U9405A-02

S E R V I C E N O T E

U9405A - i1000SFP systems

Current Digital card firmware version 06 does not support i2C/SPI “Read to File” function.

Figure 2.0

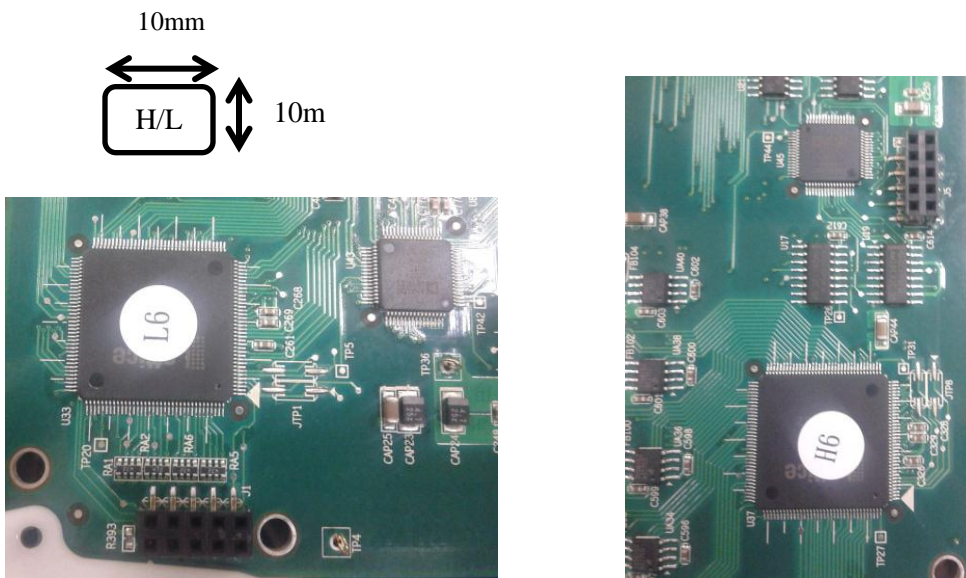
2. On top of the Lattice XP IC label, request to change from H6 & L6 to H7 & L7 as Figure 2.0
